**INSPECTION DEPARTMENT**

Mainspan PI DEFECTS

DATE. 13/06/10

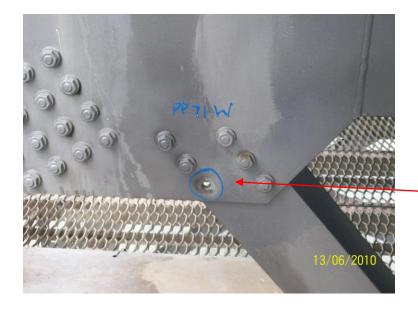
Missing bolt beam No 6 . on south face of cross girder PP71 (West. )

"A line "Tri-duct Expansion joint jubilee clips heavily corroded & broken, Require to be replaced on both E & W throughout Main-span PI. Area PP 68.5 to PP71.5.
